796-001-12

ADDENDUM NO. 2

The Architect/Engineer issues this addendum, applicable to the above named project, to all known Contractors before receipt of proposal.

This addendum includes Item Number 2-1 thru 2-35. This addendum item shall be fully incorporated into the Bidding/Contract Documents and have the same force and effect as though originally included.

Item 2-3: C3.02 – Storm Sewer Plan

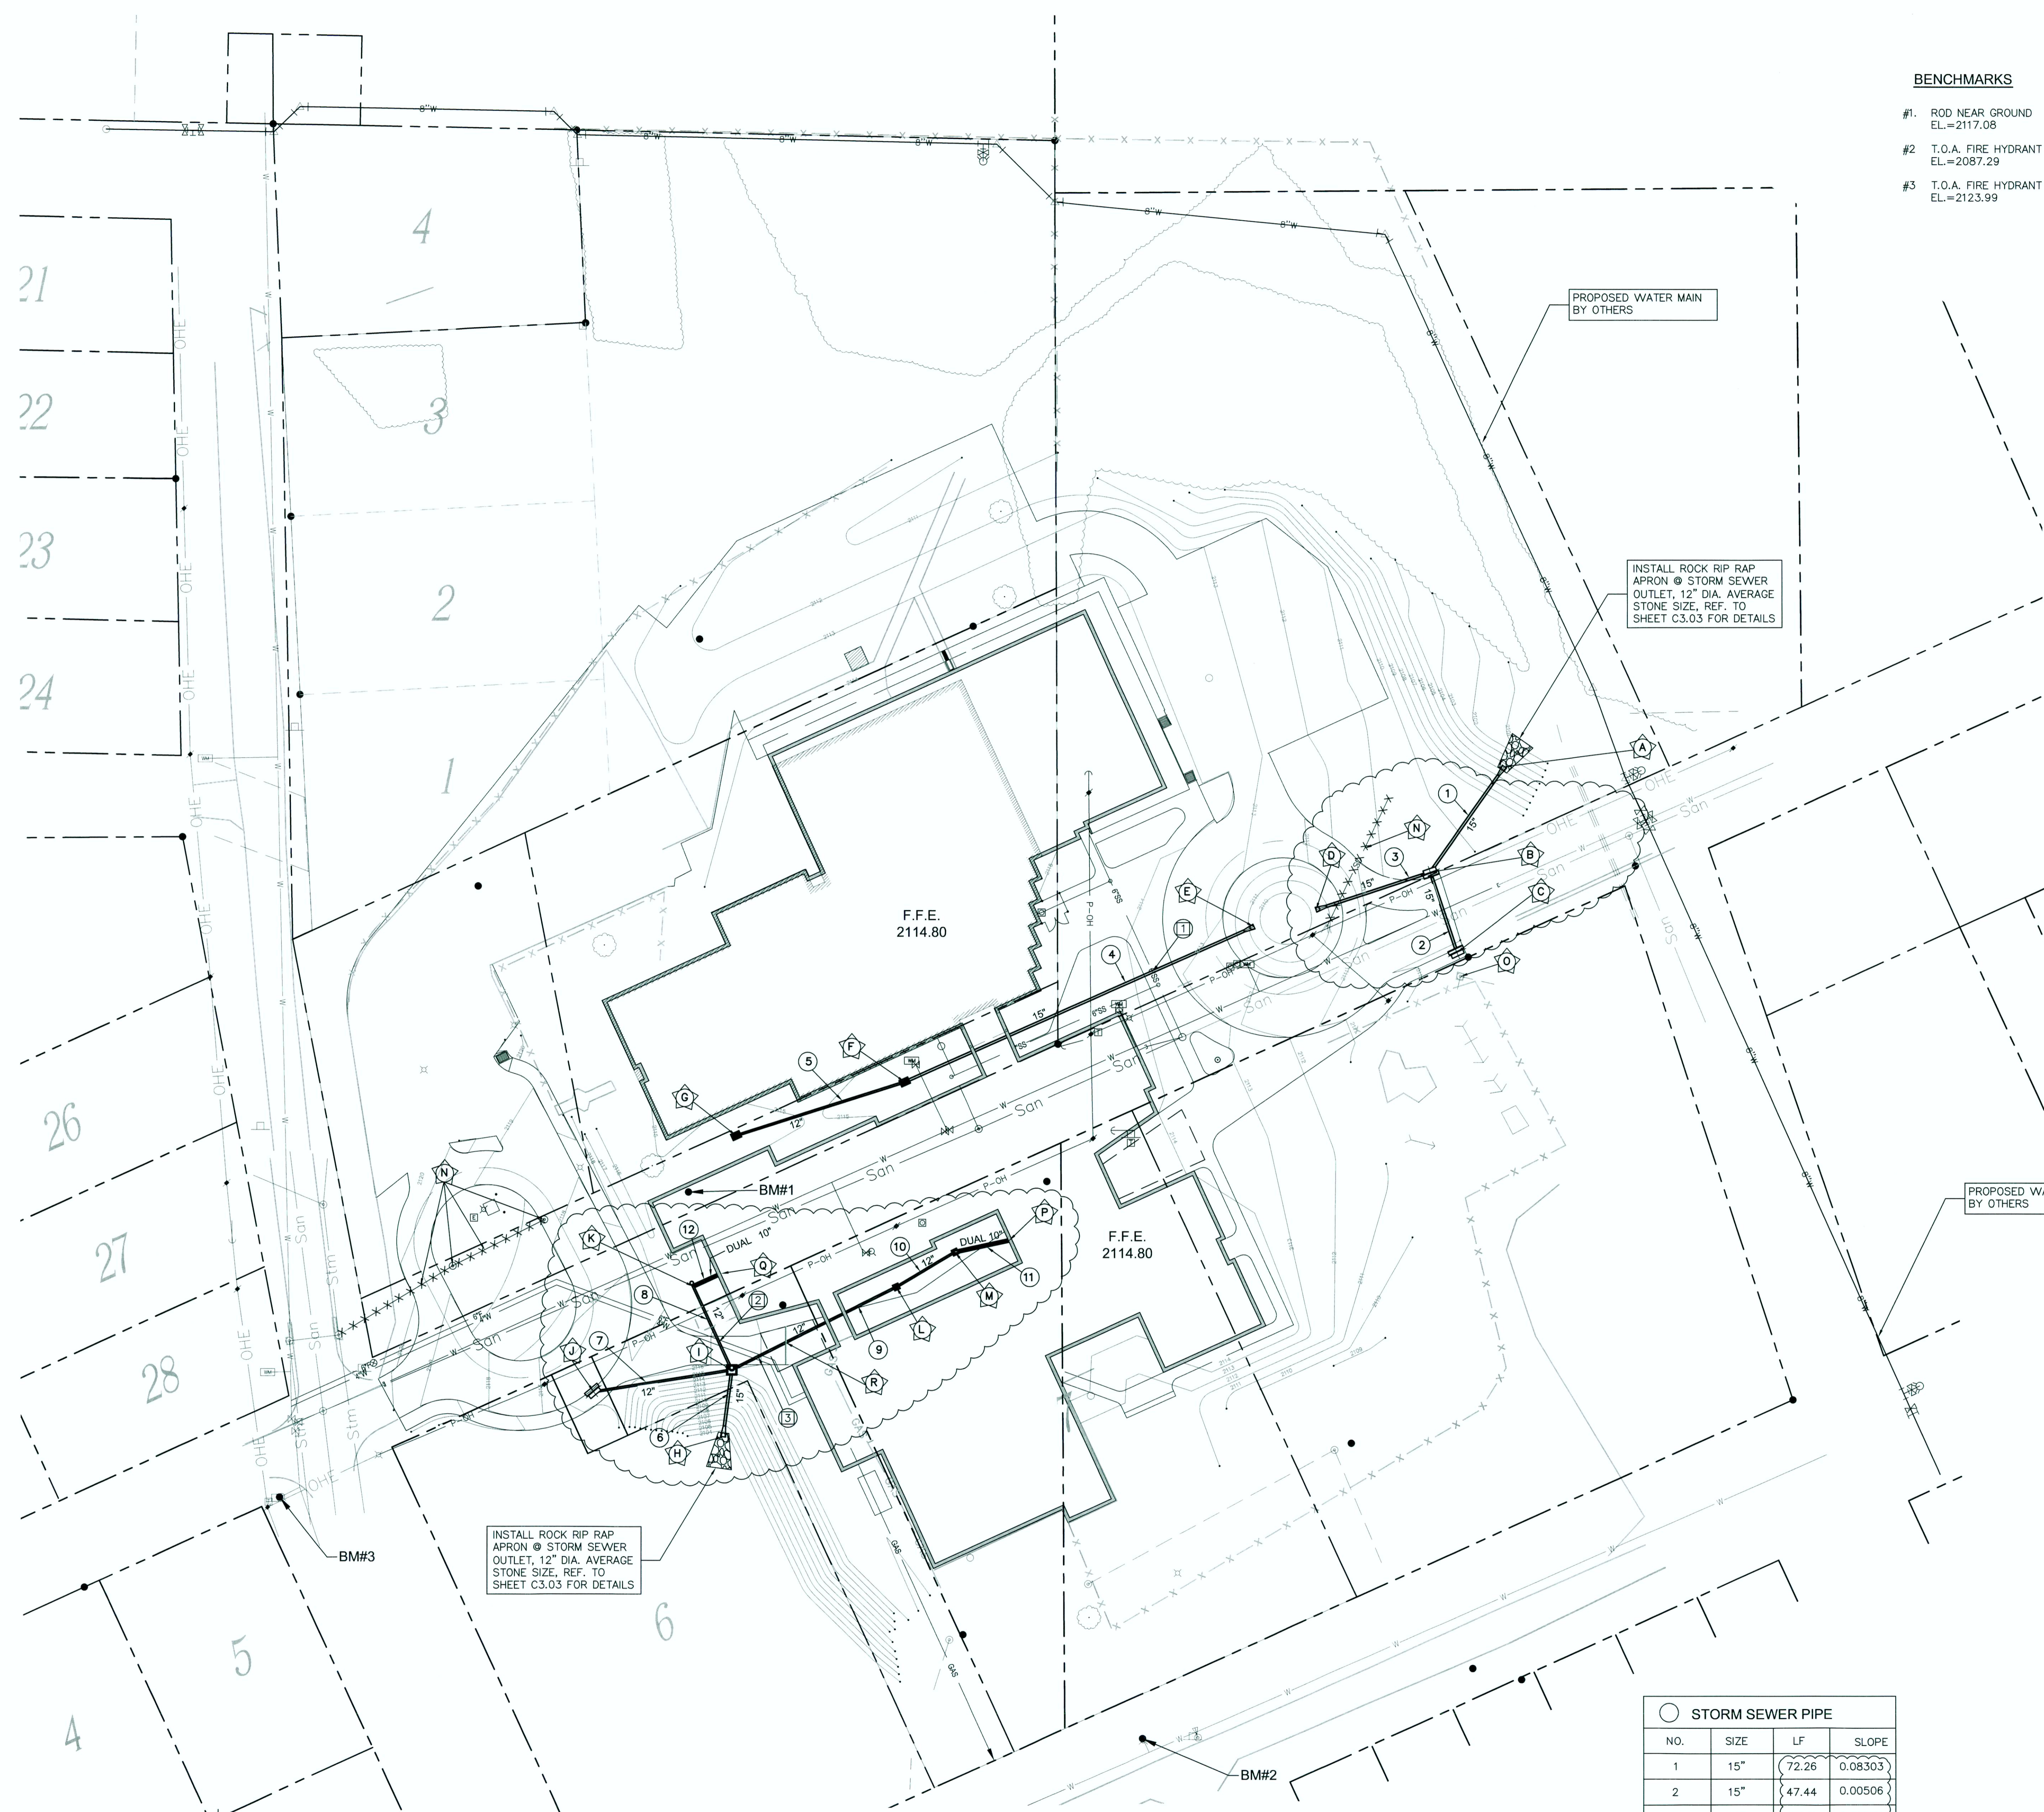
Replace sheet C3.02 in its entirety.

- A** N: 415579.52
E: 1892099.77
END OF FLARED END SECTION
FL(15")=2101.00
- B** ~~N: 415520.45
E: 1892058.15~~
BUILD
1-22" STRAIGHT CURB INLET
TC EL.=~~2110.82~~ 2110.82
FL(15")=2107.00

- C** ~~N: 415475.45
E: 1892073.17~~
BUILD
1-22" STRAIGHT CURB INLET
TC EL.=~~2110.30~~ 2110.30
FL(15")=~~2107.15~~ 2107.24
- D** N: 415499.35
E: 1891994.22
END OF FLARED END SECTION
FL(15")=2108.80

- G** N: 415373.04
E: 1891670.11
BUILD
1-TYPE "H" GRATE INLET
PER DETAILS ON SHEET C3.04
RIM EL.=2114.00
FL(12")=2112.00
- H** ~~N: 415241.98
E: 1891667.51~~
BUILD
1-STORM SEWER MANHOLE
PER DETAILS ON SHEET C3.04
RIM EL.=~~2113.50~~ 2115.00
FL(15")=2106.70
FL(12")=2106.95
FL(8")=2107.28

- I** N: 415229.64
E: 1891590.39
BUILD
1-22" STRAIGHT CURB INLET
TC EL.=2116.50
FL(12")=2113.20
- J** ~~N: 415288.80
E: 1891646.05~~
INSTALL
2-12" X 10" TEE
1-CLEANOUT PER DETAIL ON THIS SHEET
INSTALL 18 LF OF DUAL 10" STORM
SEWER PIPE EAST
RIM EL.=~~2114.00~~ 2116.30
FL(12")=2108.50
FL(10")=2108.58

- K** ~~N: 415288.50
E: 1891759.81~~
BUILD
1-2216 CATCH BASIN
PER DETAILS ON SHEET C3.04
RIM EL.=~~2114.00~~ 2114.15
FL(12")=2109.00
- L** ~~N: 415307.97
E: 1891792.69~~
BUILD
1-2216 CATCH BASIN
PER DETAILS ON SHEET C3.04
INSTALL 33 LF OF DUAL 10" STORM
SEWER PIPE EAST
RIM EL.=~~2114.00~~ 2114.15
FL(12")=2109.34
FL(10")=2109.34
